Summary: of Clarifications on CMS Condition 5

Scaled OS drawing below: noting the width of the carriageway at 4.65m: it is not necessary to suspend the parking bays. Please refer to drawing GRA-BAT-07-SP-16.50 PITLANE(PROP)

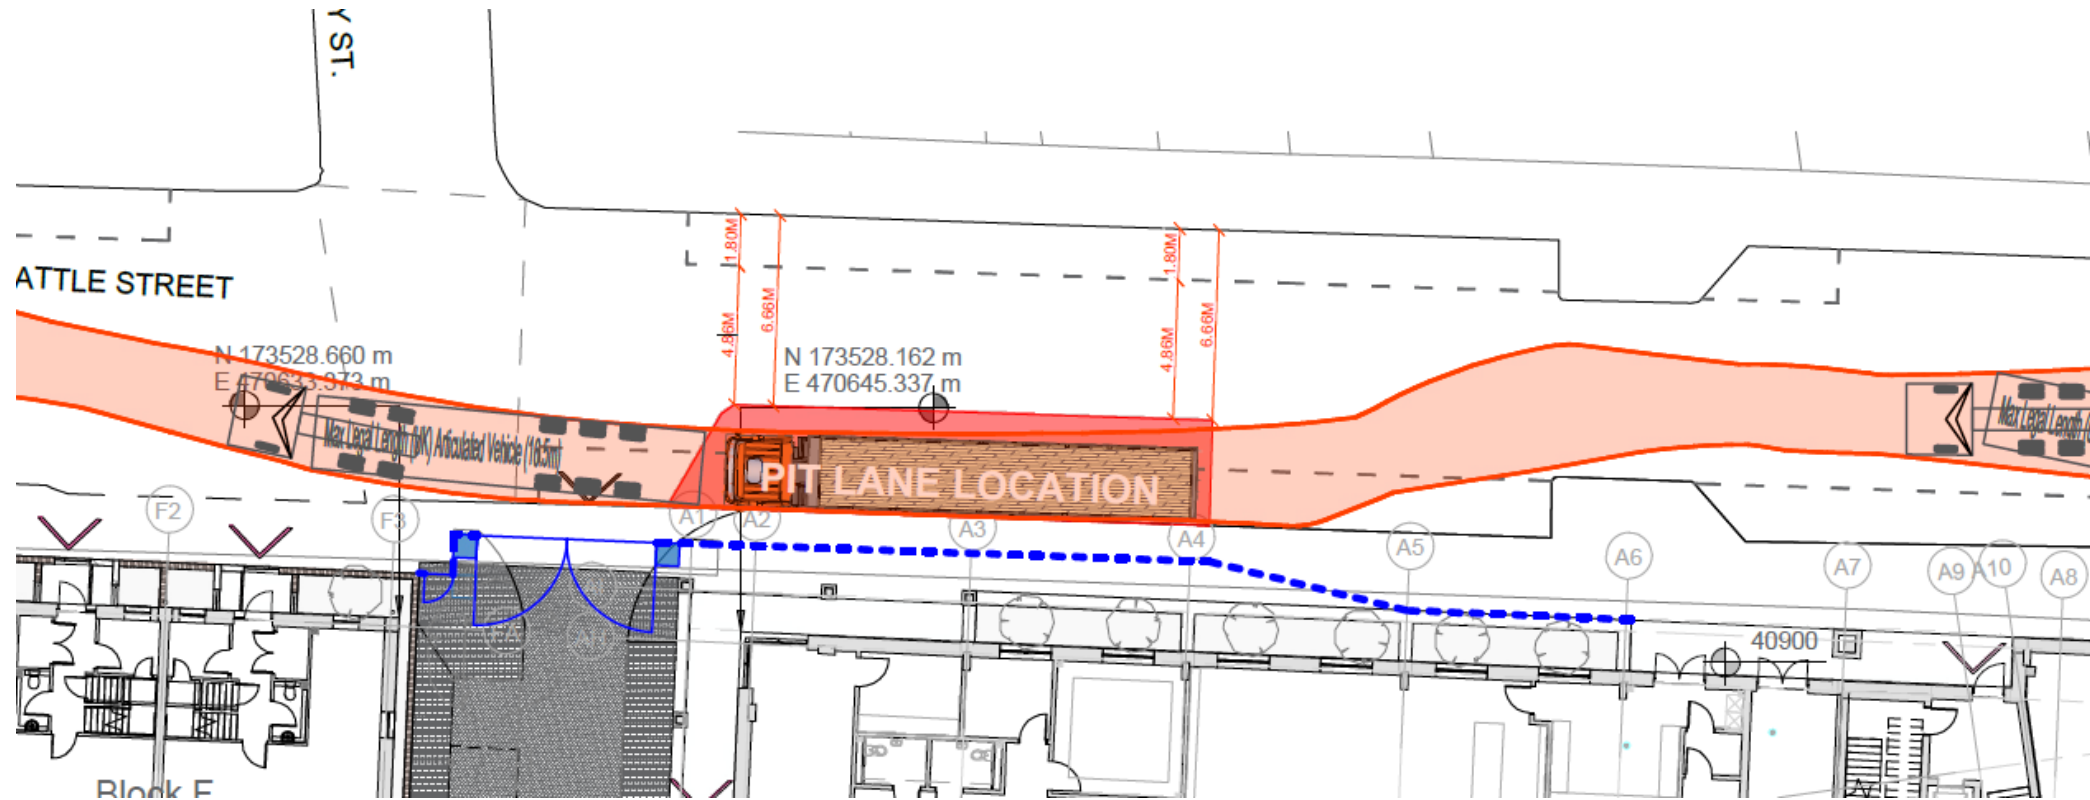
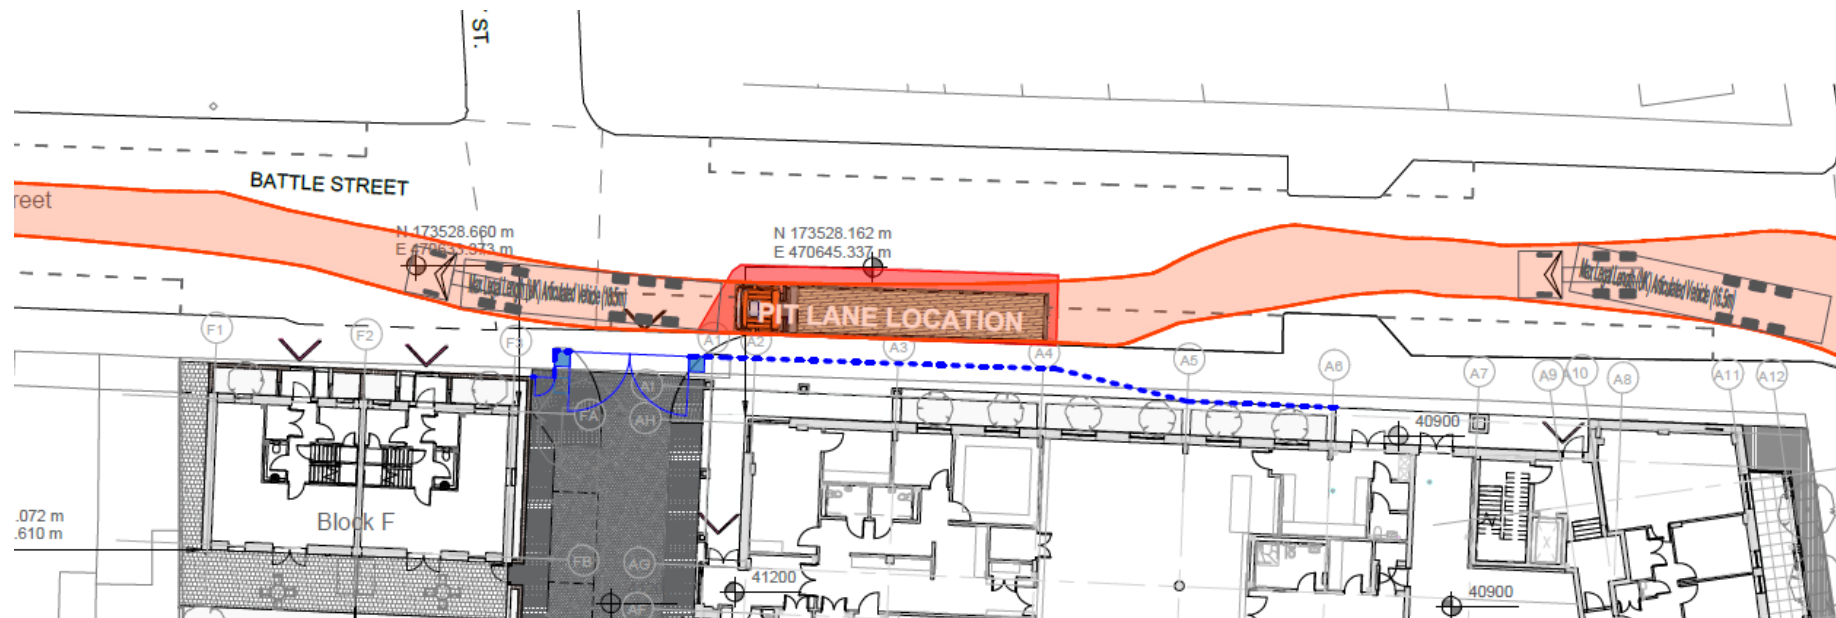
Plans show the bays behind the pit lane are to be suspended, however, scaled drawings are required illustrating the width of the carriageway between the pit lane and parking bays opposite so that a decision can be made if the parking bays opposite need to be suspended. If the width is in excess of 4.8m metres then the bays opposite the site would not need to be suspended.

We propose to close the parking bays on the south side of Battle Street. In the location shown.

Extract of tracking noting clashes within the site. Drawing reference GRA-BAT-01-SP-16.50M

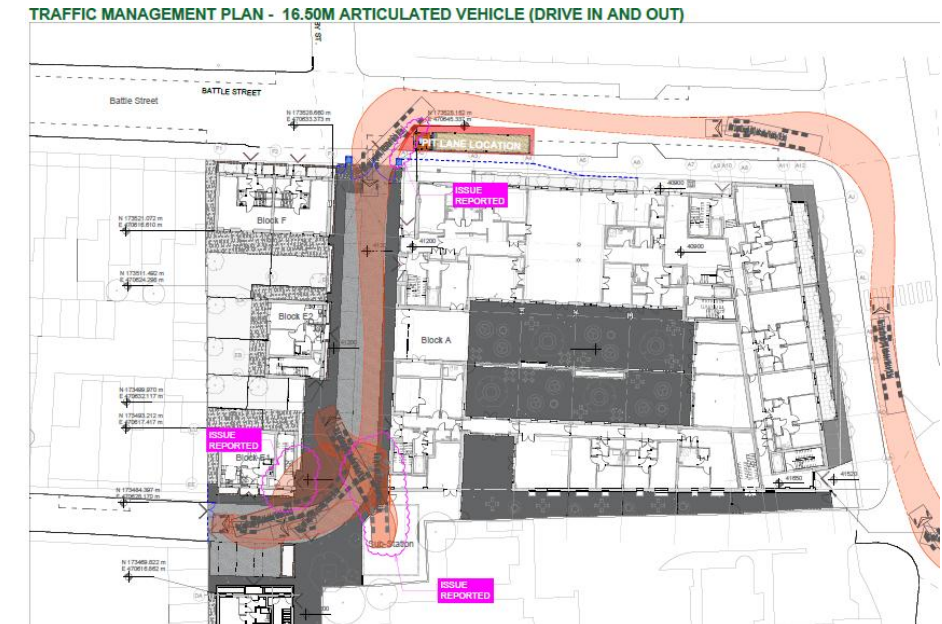
The frequency of these larger vehicles travelling on the local road network of terraced resident properties is high and as previously stated the Highway Authority are not going to accept large number of articulated vehicles travelling around terraced residential streets and therefore alternative routes will need to be provided.

It is not possible for large vehicles to enter the site, turn and exit the site in forward gear.

Nor is it possible for a large vehicle to reverse into the site and exit the site in forward gear.

As part of the development of the CMS tracking has been undertaken to check the feasibility of reversing vehicles within the site.

The only option is for a large vehicle to park adjacent to the site, load / unload on Battle Street, then exit back onto the principal highway network via George Street, Great Knollys Street and Bedford Road. Tracking is provided.

SWEPT PATH ANALYSIS - 16.50M ARTICULATED VEHICLE EGRESS

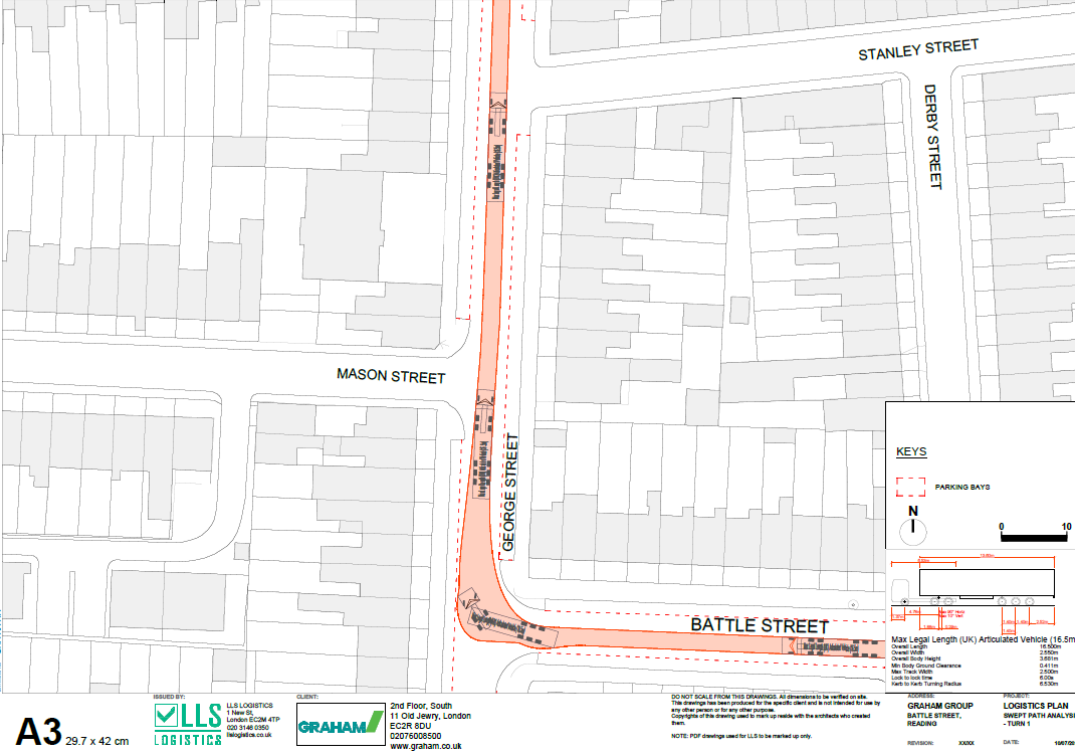
3. Plans do not show how the larger vehicle will exit the area and back on to the main road network given that the vehicle illustrated is turning right from Battle Street on to George Street and on to terraced streets. More information is required.

Tracking has not been provided for the full route and it is evident from the images provided that the overlaying lines do not correspond with the aerial image beneath therefore providing sufficient evidence that the swept path analysis provided is in fact accurate. However, as stated above the Highway Authority will not accept high volumes of large articulated vehicles travelling around terraced residential streets.

Further tracking has now been undertaken to demonstrate clear vehicular access routes around the streets with specific consideration to parking bays and junctions. See below and drawing reference GRA-BAT-06-LOCAPLAN

Drawing reference GRA-BAT-07-SP-16.50PITLANE(EXIST)
Pit Lane established with the existing bellmouth.

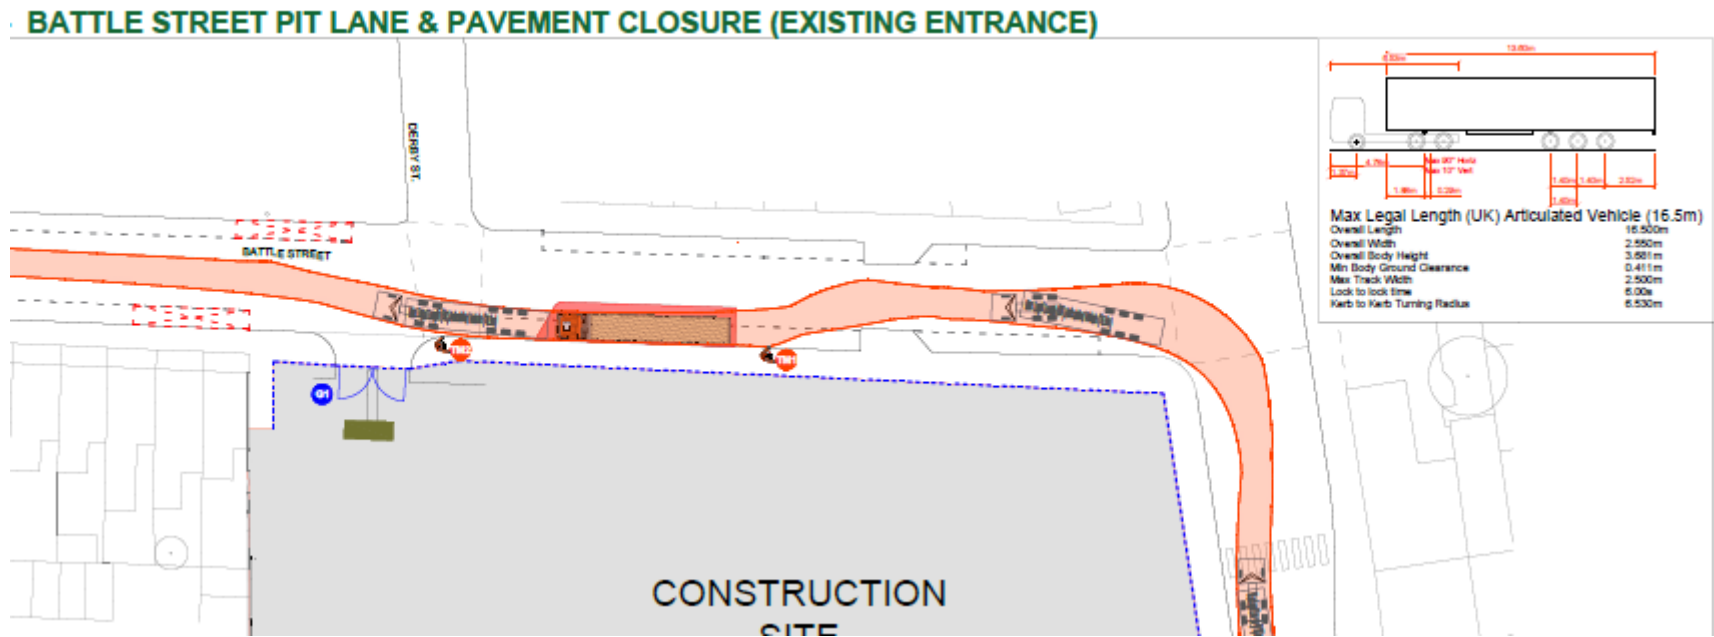
4. Access: Plans identify G1 as the new access area which will be the point vehicles will enter the site. However, confirmation is required what the strategy will be whilst the existing access is being utilised.

*S278 agreement- Drawings have yet to be approved and with agreements required to be signed this may still take a considerable time to progress.
It is also noted that the build outs identified on the logistics plans are as per the proposed location and not the existing, this will cause an issue getting on to the pit lane as the build out is directly behind it. It is therefore imperative that the CMS includes a detailed methodology for how works will take place prior to any of the Highway works coming forward.*

S278 agreement. In the event the design and or agreements cause a delay to the proposed construction date the strategy for entering and existing the site is to use the existing bell mouth for smaller vehicles. Following the completion of the S278 works the new bell mouth will be utilised. Please refer to drawing reference GRA-BAT-06-SP-16.50PITLANE(EXIST) & GRA-BAT-07-SP-16.5PITLANE(PROP)
Smaller vehicles such as concrete wagons, skip wagons and small delivery vehicles will enter the site and be revered with the site to exit via Battle Street.
